Addendum No. 1 to an Environmental Impact Report

Addendum No. 1 to the Environmental Impact Report for the Sycamore Canyon Business Park Buildings 1 and 2 Project (State Clearinghouse No. 2015081042; Project) has been prepared by the City of Riverside Planning Division (“City”) in conformance with the California Environmental Quality Act (Public Resources Code, § 21000 et seq.) (“CEQA”), the *CEQA Guidelines* (Cal. Code Regulations, Title 14, Chapter 3 § 15000 et seq.) and the City of Riverside Resolution No. 21106 (Local CEQA Guidelines), to address minor changes to construction methodology of the Sycamore Canyon Business Park Buildings 1 and 2 (described below) to include limited blasting on portions of the Project site.

Figure 3 - Revised Blasting Activity Locations
Sycamore Canyon Business Park Buildings 1 and 2
EIR Addendum No. 1

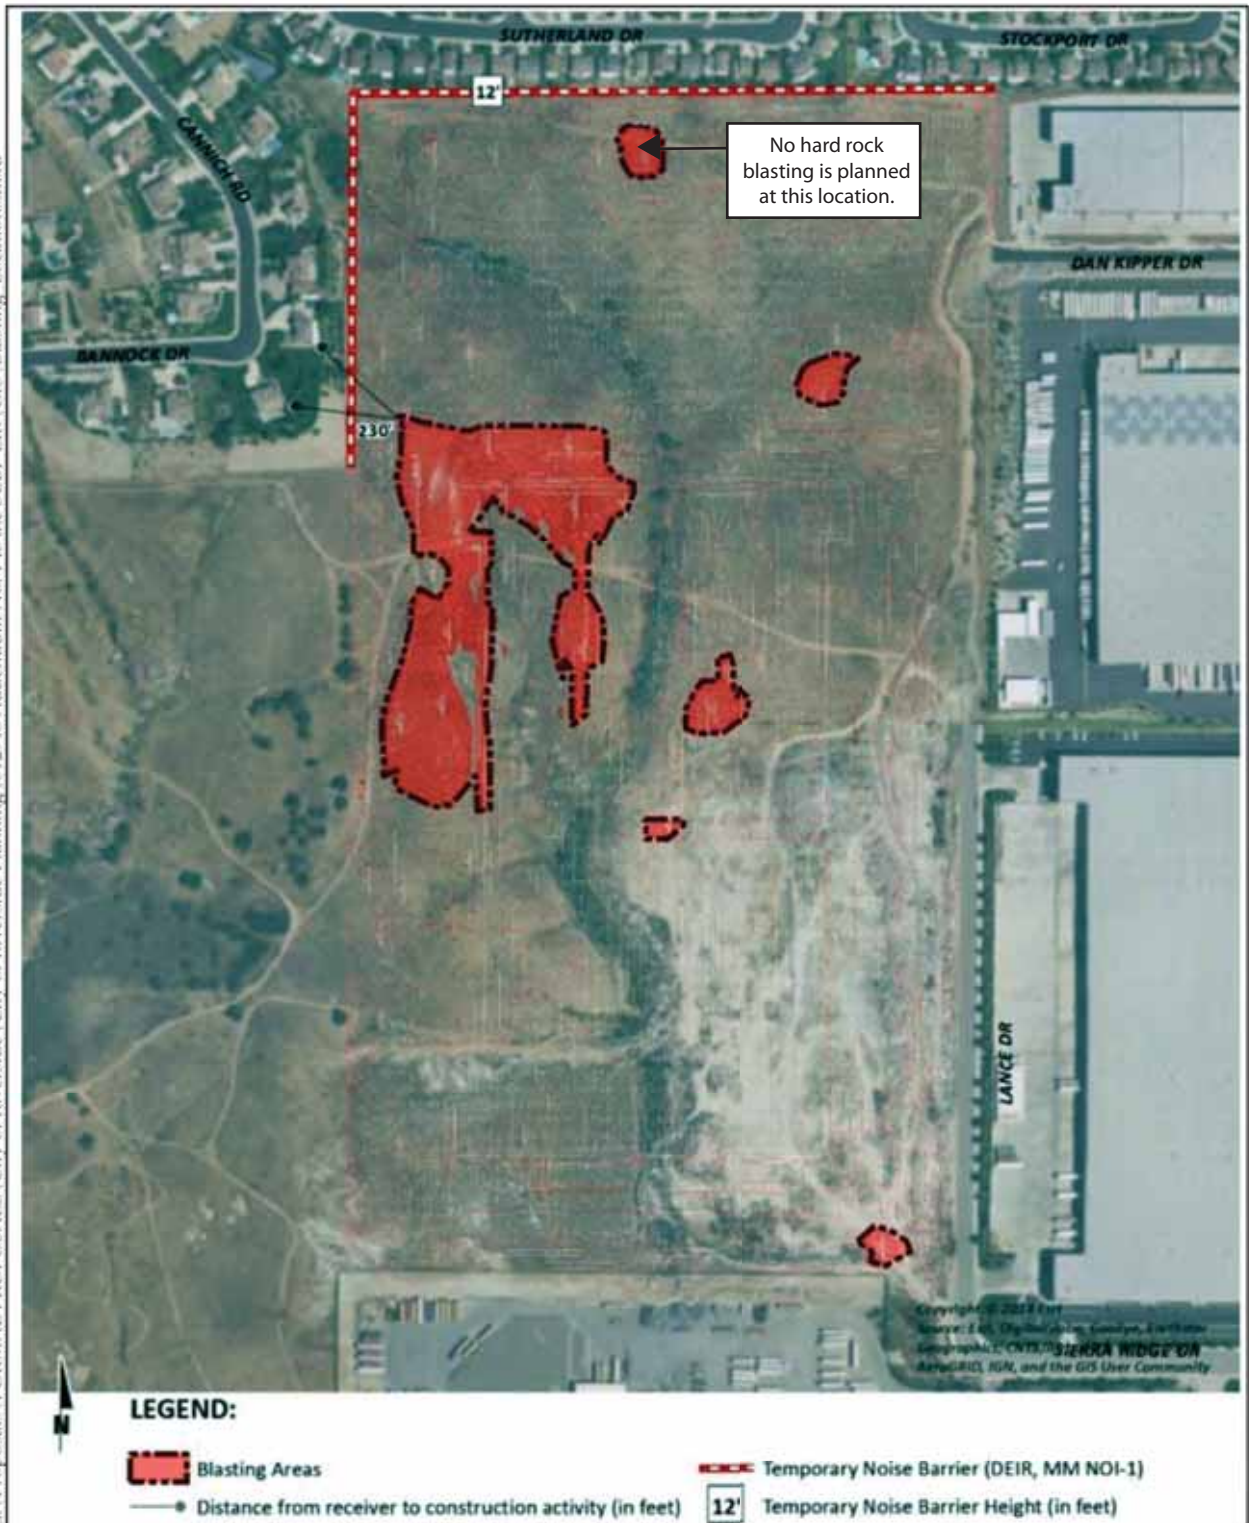
The Project Applicant plans to engage in additional meetings and coordination with residents to the north and west of the Project site regarding minor changes to the Project's approved construction methodology (i.e. mechanical grading) and mitigation measure **MM NOI 12**. In order to reduce the amount of time mechanical grading equipment will be in use in certain areas of the Project site, the Project Applicant is proposing blasting activities in the areas shown on **Figure 3 – Revised Blasting Activity Locations** during the grading phase of Project construction.

The Project Applicant is proposing blasts would occur at the edge of the blasting areas identified in **Figure 3 – Revised Blasting Activity Locations**. Based on information provided by the Project Applicant and blasting contractor (California Drilling and Blasting Co., Inc.), blasts will be below-ground and will be partially, if not substantially, contained, depending on the depth of the hard rock areas within the Project site. Blasting at the Project site is anticipated to occur during the grading stage of Project construction, which is estimated to last for roughly 60 days, with approximately seven to nine blasting events necessary to break the hard rock within the site. A blasting event is comprised of multiple charges that are set off at one time. Each blasting event is over within seconds and the events are spaced out over days to weeks apart. Alternative rock-breaking methods, if used, would be anticipated to result in a longer grading period of 122 days, with 47 days of rock-breaking activities including the use of excavators and impact hammer equipment. (Refer to Appendix A of this Addendum).

MM NOI 12: During grading activities, ~~No~~ no blasting shall take place on the Project site ~~except~~ for the areas depicted in Figure 3 of Addendum No. 1 to the Environmental Impact Report for the Sycamore Canyon Business Park Buildings 1 and 2 Project. No other construction equipment shall operate during each blast in the blast area, but can commence operation once the blasting contractor indicates it is safe to do so.

Therefore, the Revised Project's clarification to Section 5.12.4, Project Design Features, in the Noise Section to allow blasting in areas identified in **Figure 3 – Revised Blasting Activity Locations**; the clarification to Mitigation Measure **MM NOI 12** to allow blasting in areas identified in **Figure 3 – Revised Blasting Activity Locations**; and the requirement that the Project Applicant obtain a permit from the Fire Chief for blasting activities as mentioned in the Hazards and Hazardous Materials section of the EIR will not result in new or more severe impacts than those already disclosed in the certified EIR.

EXHIBIT A: BLASTING ACTIVITY LOCATIONS

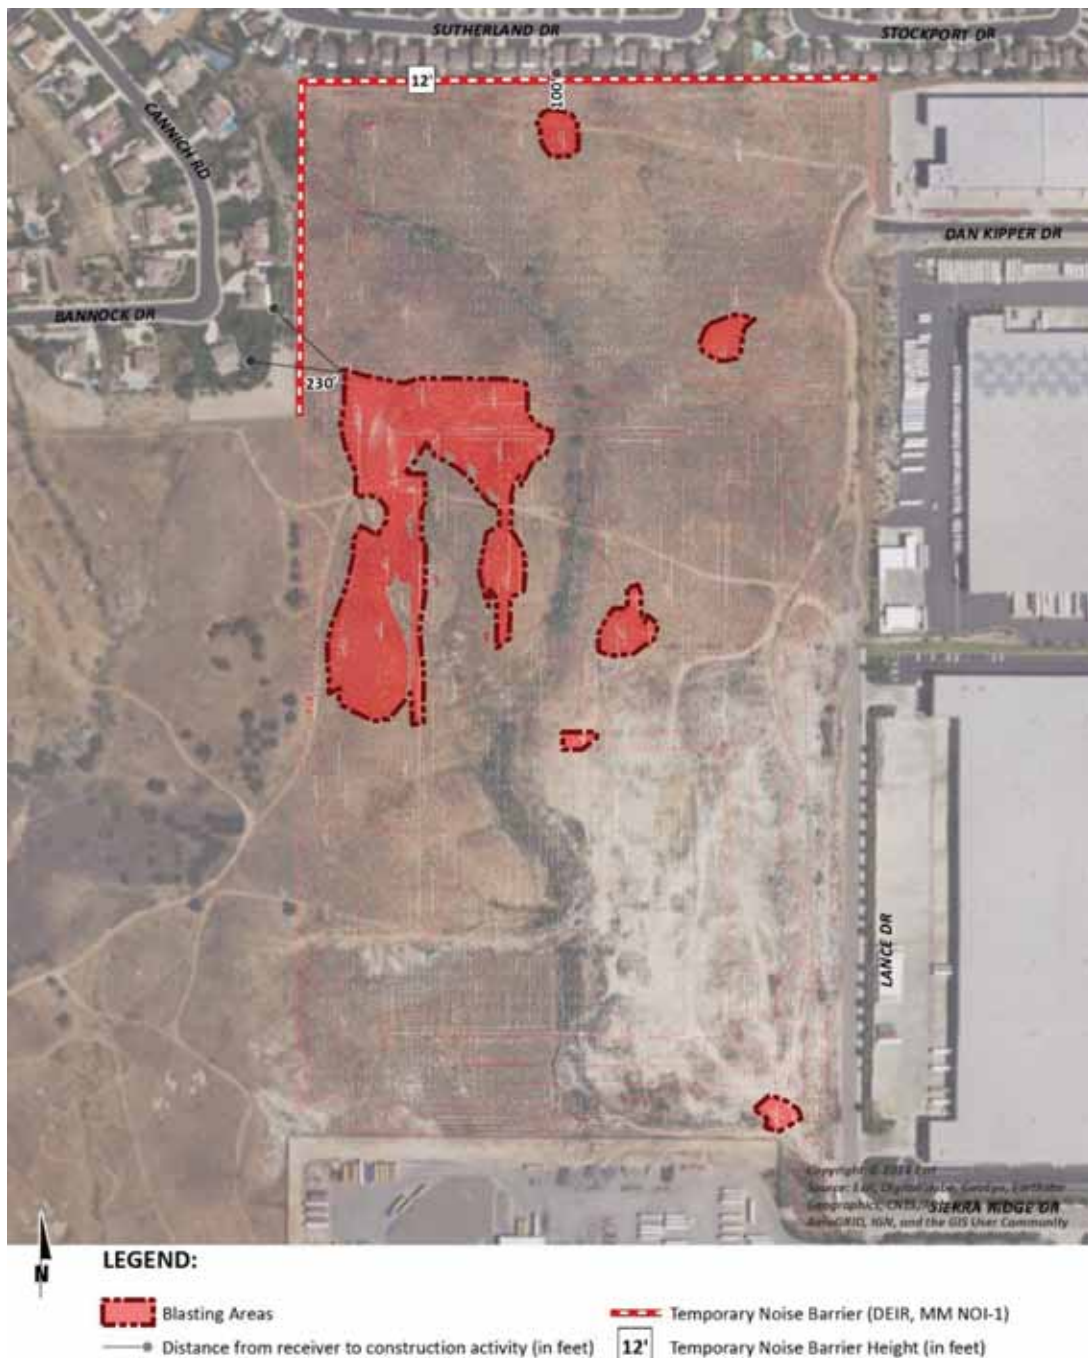
The Project includes potential blasting activities in the areas shown on Exhibit A, based on the November 14th, 2017 *Sycamore V Hard Rock Exhibit* prepared by Boberg Engineering & Contracting, Inc. (3) To present a conservative approach, this analysis assumes that blasts would occur at the edge of the blasting areas indicated on Exhibit A. Based on information provided by the Project Applicant and the blasting contractor, California Drilling and Blasting Co., Inc., the blasts will be below-ground and will be partially, if not substantially, contained, depending on the depth of the hard rock areas within the Project site. Additional information provided by the blasting contractor, including calculation parameters, is included in the vibration and airblast calculations in Appendix A.

Table 1 shows the calculated vibration levels for the worst-case (closest) blast locations near the adjacent residential homes north and west of the Project site. The vibration levels of Project blasts are expected

to range from 0.35 to 0.37 in/sec PPV based on the distances to nearby residential homes, previously shown on Exhibit A. Calculations for both the northern and western blasting areas are provided in Appendix A.
